TULSA METROPOLITAN AREA PLANNING COMMISSION

For Meeting No. 2479

May 2, 2007

White Surveying (L-20090) (AG) (County)
10535 North Sheridan Road

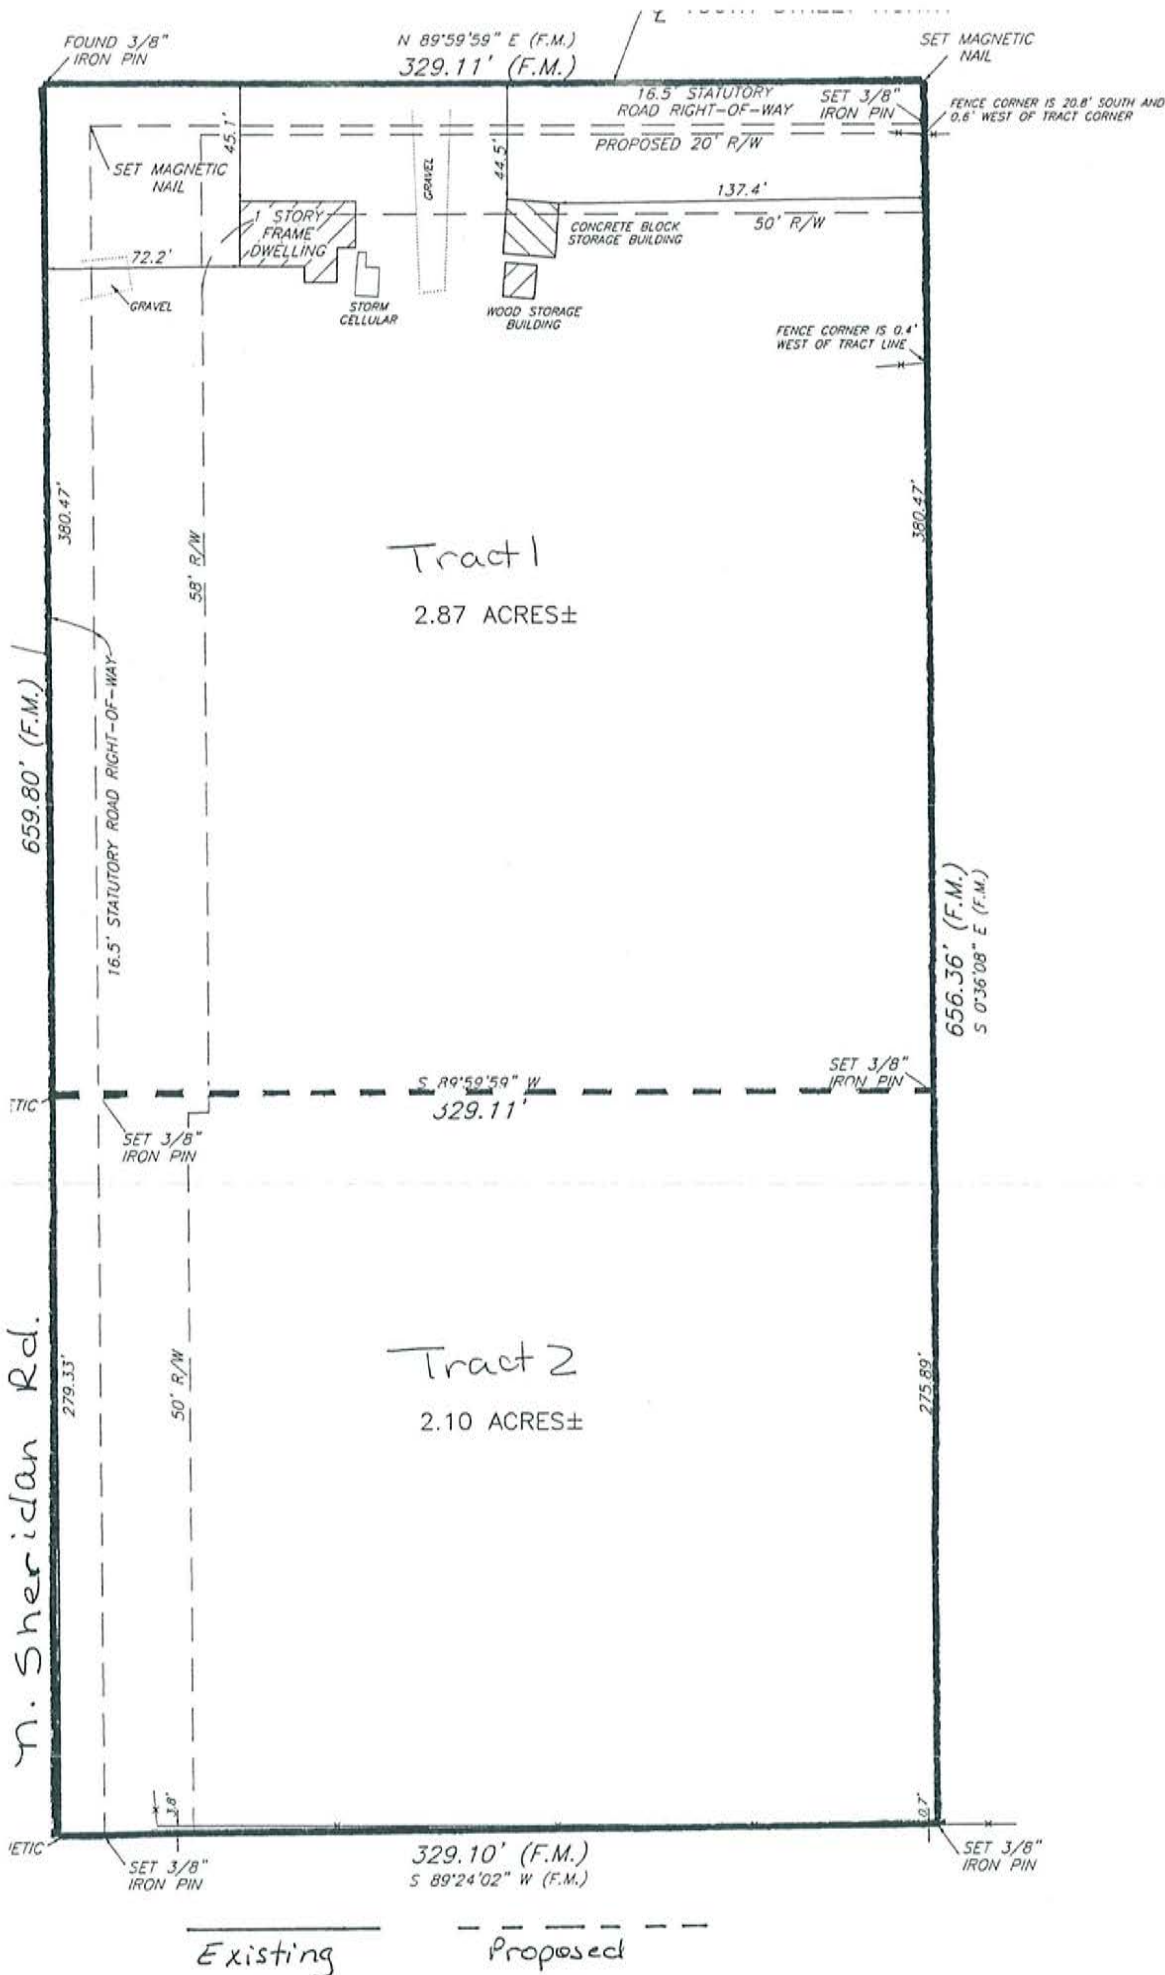
Both North Sheridan Road and East 106th Street North are designated as secondary arterials on the *Major Street and Highway Plan (MSHP)* requiring 100' right-of-way, 50' on either side of the center line. The *MSHP* also requires an additional 8' along Sheridan Road for a distance of 388' from the section line, and a 30' radius at the intersection.

The owner has agreed to give the required right-of-way along Sheridan and the radius at the intersection. However, because of the location of the existing dwelling and accessory building, the owner has requested a waiver of the requirement along 106th Street North from 50' to 20'. The dwelling is 45.1' from the centerline of 106th Street North and the accessory building is 44.5'.

The Technical Advisory Committee (TAC) reviewed this application at their April 19, 2007, meeting, and recommended that the full right-of-way be given along Sheridan Road and a minimum of 30' of right-of-way be given along 106th Street North. It was also noted that 106th Street North is designated on the Trails plan as an on-street bikeway linkage.

Given the location of the existing structures and TAC's recommendation for a minimum of 30' along 106th Street North, Staff recommends **APPROVAL** of the waiver of *Subdivision Regulations* from 50' to a minimum of 30' along 106th Street North, subject to required right-of-way of 50' to 58' along Sheridan Road and the 30' radius at the intersection be given to Tulsa County.

AMENDED
EXHIBIT 'B' SITE PLAN
FOR
FIESTA MART
IN PART OF
LOT 2 IN BLOCK 1
OF

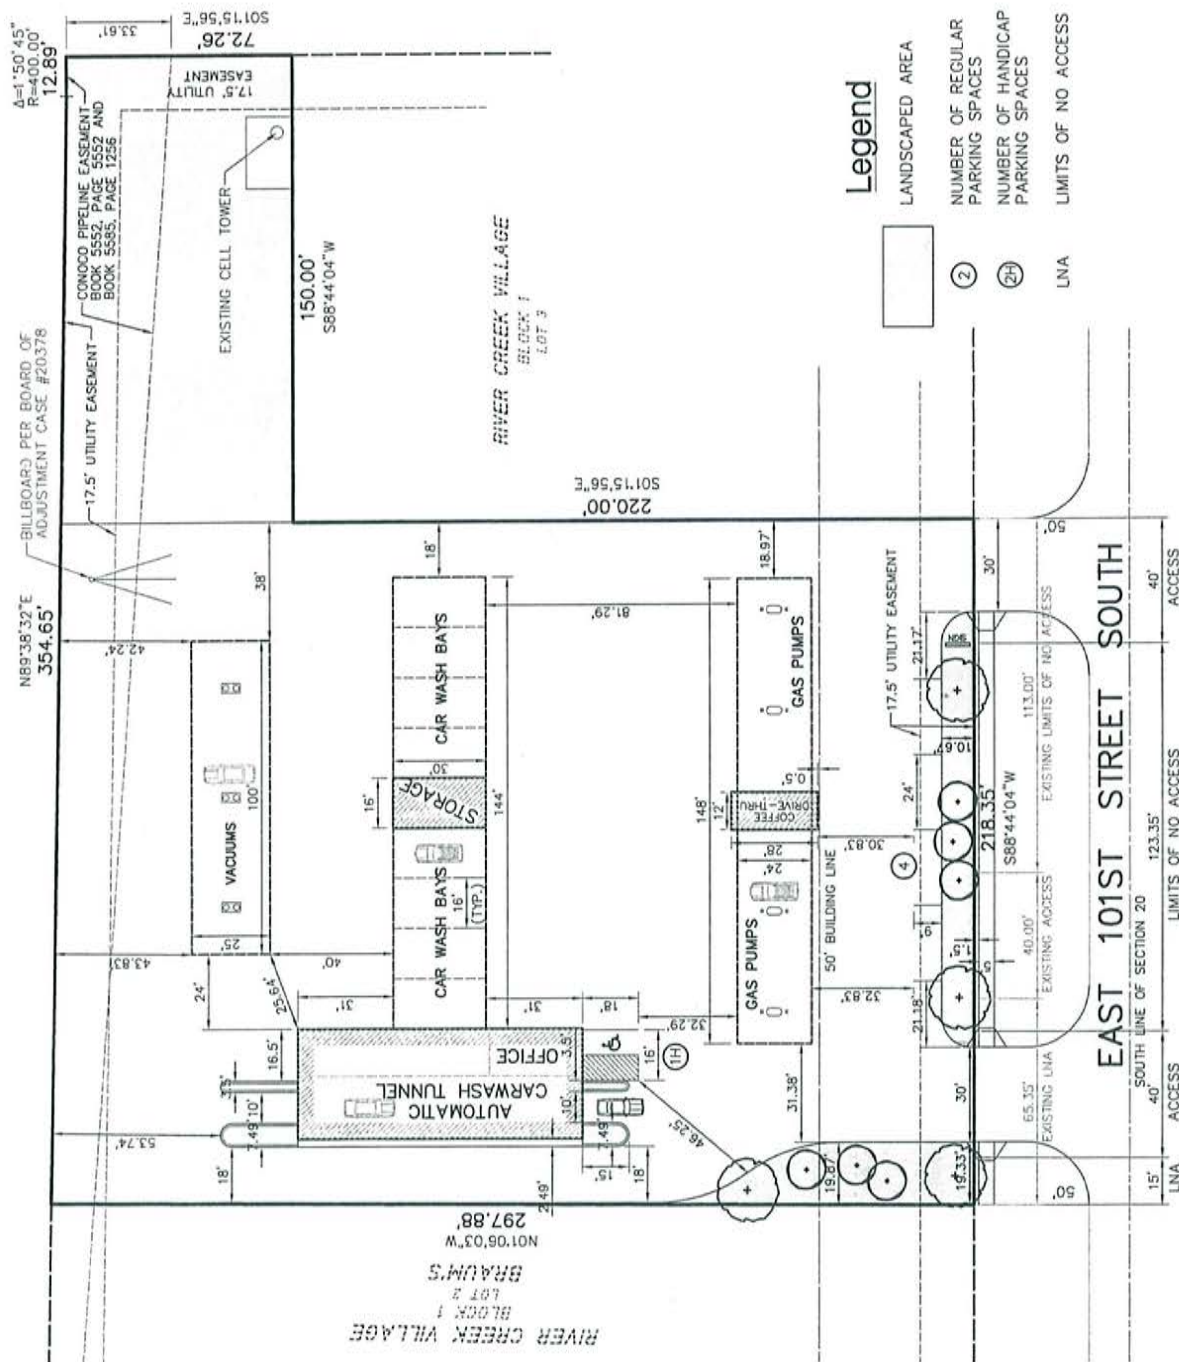
- Verify approved "Change of Access" (this has been done).

- The property has access to an existing sanitary sewer line, and no additional easements are needed.

- A 12 inch waterline exists on north side of 101st Street South. Service connection is required.

- Where a portion of the facility or building hereafter constructed or moved into or within the jurisdiction is more than 400 feet from a hydrant on a fire apparatus access road, as measured by an approved route around the exterior of the facility or building, on-site fire hydrants and mains shall be provided where required by the fire code official. For Group R-3 and Group U occupancies, the distance requirement shall be 600 feet. For buildings equipped throughout with an approved automatic sprinkler system installed in accordance with Section 903.3.1.1 or 903.3.1.2, the distance requirement shall be 600 feet.

Staff recommends **APPROVAL** of the plat waiver.

LOOKOUT MOUNTAIN ESTATES^{of}

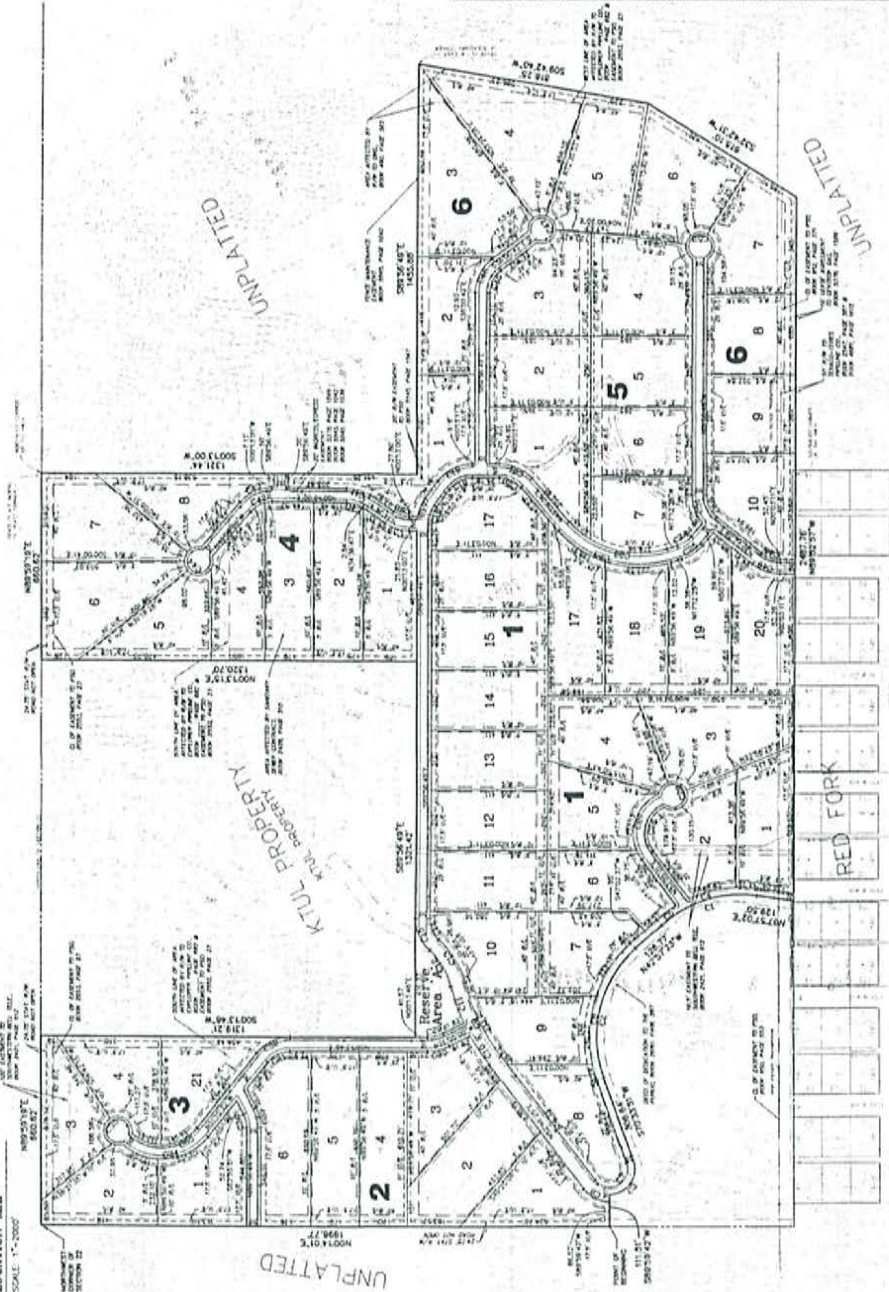
1. **Zoning:** The property is zoned AG. There was a sketch plat reviewed on this property in June of 2006. No half street dedications will be accepted. Reserve areas need to be shown and clarified. Easements need to be dimensioned. Release letters from easement holders and the fire department responsible for service will be required before Final Plat approval. Show lot sizes. Sidewalks are required. Watch the cul-de-sac and block lengths or waivers will be required.

2. **Streets:** Cul-de-sacs exceed the 750 foot maximum length. Lots 10 through 17 in Block 1 comprise a block length exceeding the 1500 foot maximum. At north ends of existing 27th West and 28th West Avenues, cul-de-sacs turn-arounds are recommended.

3. **Sewer:** Additional easements may be required to accommodate the required sanitary sewer mainline extension. Omit Section 1.3.6 and Section II R pertaining to aerobic systems if water service by City of Tulsa. An SSID is required to extend sanitary sewer service to all lots. If an area can not gravity flow to the sanitary sewer main, then Engineering Services will require the construction of a public lift station and force main. Developer and engineer should meet with City of Tulsa Engineering Services, Design Engineering, to determine requirements. The City will require at least a dry system if water is to be served to this site.

4. **Water:** Area can be served by a City of Tulsa primary system. A water main extension contract (wmec) will be required and conditioned on meeting sanitary sewer connection requirements. Water lines on cul-de-sac roads must be looped. No fire hydrants are shown. Elevated tank may be required to accommodate fire flow. Booster pumps may be required. Upgrade of system to the south may be required.

5. **Storm Drainage:** This subdivision cannot increase the volume or velocity of the drainage flowing from their development into the City of Tulsa. Stormwater detention may be required. Stormwater detention facilities should be placed in Reserve Areas, which should be maintained by the

Homeowners Association. Drainage flowing onto the development from off-site must be conveyed in an overland drainage easement, or must be collected and piped in a storm sewer easement. Standard language must be added for stormwater detention in a Reserve, and for overland drainage easements in Reserve Areas. Drainage maintenance responsibility should be Tulsa County, not the City of Tulsa. A conceptual drainage plan was not submitted, and it is required.

7. **Other: Fire:** Cul-de-sacs shall not exceed seven hundred and fifty feet in length, measured from the centerline of the intersecting streets to the center of the turn-around. Cul-de-sacs shall have a turn-around radius of not less than thirty-eight feet of paving, utilizing a rolled curb section wherever possible, and a radius of fifty feet of right-of-way at the property line. Cul-de-sacs greater than two hundred and fifty feet in length shall have a turn-around radius of not less than forty feet of paving and a radius of fifty-two feet of right-of-way at the property line. Cul-de-sacs greater than five hundred feet in length and with abutting front yards for more than twenty lots shall have a turn-around radius of not less than forty-eight feet of paving and a radius of sixty feet of right-of-way at the property line. For a cul-de-sac with a rolled curb section the turnaround radius may be measured to the back of the curb. Fire apparatus access roads shall not exceed 10 percent in grade. Grades steeper than 10 percent as approved by the fire chief. Where a portion of the facility or building hereafter constructed or moved into or within the jurisdiction is more than 400 feet from a hydrant on a fire apparatus access road, as measured by an approved route around the exterior of the facility or building, on-site fire hydrants and mains shall be provided where required by the fire code official. Exceptions: 1. For group R-3 and group U occupancies, the distance requirement shall be 600 feet. 2. For buildings equipped throughout with an approved automatic sprinkler system installed in accordance with Section 903.3.1.1 or 903.3.1.2, the distance requirement shall be 600 feet. Water mains shall be looped where serving fire hydrants.

County Engineer: Standard right-of-way for County streets is 60 feet. Line up centerline of 29th West Avenue with street to the south. (Existing 29th West Avenue has 100 foot right-of-way.) Deed of Dedication for continuation of 29th West Avenue is 50 feet, should be showing additional 10 foot dedication by this plat. Complete and correct location map (33rd West Avenue, not 37th). Twenty five foot radii at all intersections are needed. Show complete width of all easements. Two lot 17's in Block 1. Block 5 and 6 are continuous, should be combined into Block 5. Lot 21, Block 3 should be Lot 5. Northern end of Lot 1, Block 6 looks unuseable and probably should be a Reserve Area. Street names and addresses will be assigned by E911. The last call in the description says due west, but is a bearing on face of plat. Section 1.3, City of Tulsa to be responsible for water, sewer if installed. Tulsa County will be responsible for storm sewer. DEQ responsible for septic systems. Section 1.8, description of use for Reserve A has been

left out, and maintenance should be responsibility of "Homeowners Association", not owners. There are some long blocks and cul-de-sacs. Drainage easements will probably be needed, but no drainage plans have been provided. Street address and square footage of each lot need to be shown. Substantial areas are shown to be affected by existing right-of-way easements and other contracts, but recording references and delineations are incomplete; all such information needs to be included on face of plat. Show Tulsa City Limits. Section I., 1.8 appears to have missing information about Reserve A. **GIS:** Need map scale. Need e-mail address of surveyor and engineer. Cannot find date of preparation. Location map needs location and names of surrounding subdivisions; add 31st Street South on north edge, and correct west edge 37th West Avenue to 33rd West Avenue. Please show point of commencement on plat with distance and bearing to point of beginning. Show basis of bearing. Streets need to be named/labeled. Correct addressing/numbering is needed for lots.

Staff recommends **APPROVAL** of the Preliminary Subdivision plat subject to the TAC comments and the special and standard conditions below.
